**RE: Civil Site Design
North Hampton Public Library, 239 Atlantic Avenue, North Hampton, NH**

Wilcox & Barton, Inc. is pleased to submit this letter outlining the basis for design for the new North Hampton Library at 239 Atlantic Avenue in North Hampton, New Hampshire. The site design involved several factors including the following:

We understand a local resident prepared an Alternate Design and we have reviewed the sketch with the Trustees, Design Team, the NHDES and New Hampshire Department of Transportation (NHDOT). The Alternate Design is included below.

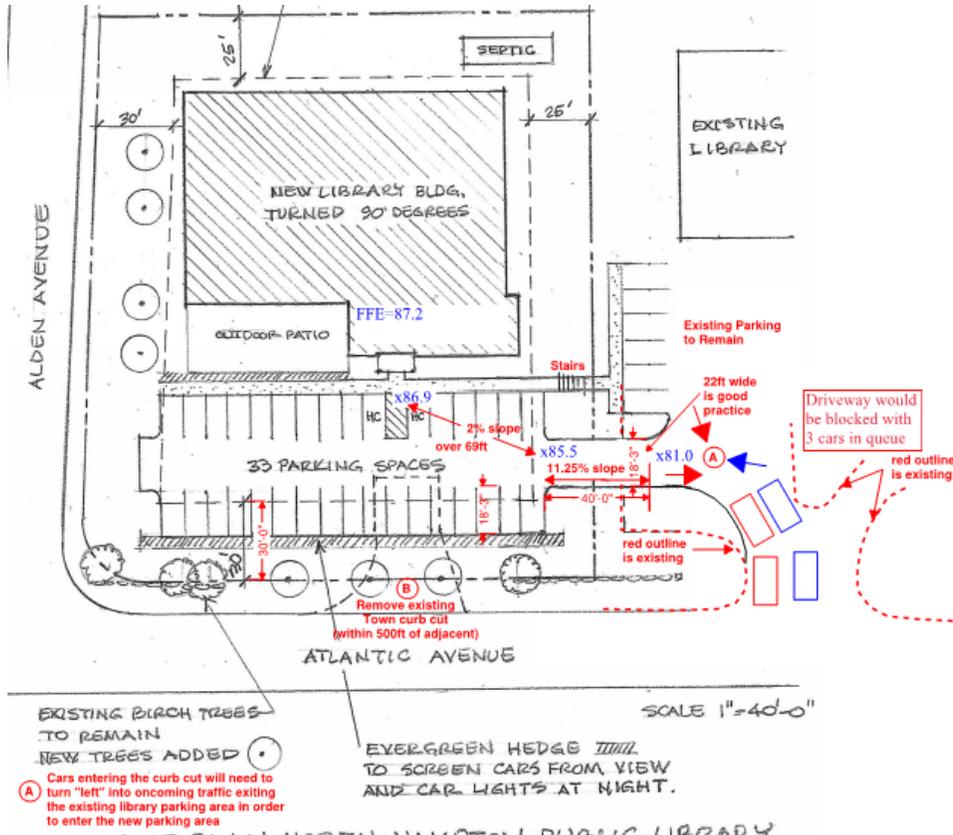
We reviewed the Resident-Alternate Design and offered the following concerns in our review with the Trustees.

Controlling pre- and post-development stormwater runoff is not possible if the grades of the new library and parking lot are lowered. Excavating and installing an underground infiltration gallery in ledge (rock) will create a basin where stormwater cannot infiltrate. This is a concern our design avoids. The current design has the building and parking at a higher elevation that allows stormwater to infiltrate through soil above the ledge.

Parking located in front of a library would require a vehicle entering the site to make a left turn, crossing traffic exiting the existing library parking and town offices. Cars queuing to exit the site will block access to the new parking lot creating congestion on site. In addition, the grade between the existing parking area and the new parking will require a grade of more than 10% which is not considered a good travel slope. Our design avoids these grading, traffic crossing, and traffic congestion concerns.

Utilizing the existing Homestead property curb cut, which is currently closed off, would require the existing library parking lot driveway to be closed due to the maximum number of curb cuts (driveways) allowed by NHDOT for properties under common ownership.

“...As for your question regarding the residents design it does create potential conflicts and queuing issues at the entrance to the new parking area. ..”

For all the reasons above, we believe the current design is the cost-effective and safe approach to the site design. If you have any questions, or require additional information, please contact me at (603) 731-9883.
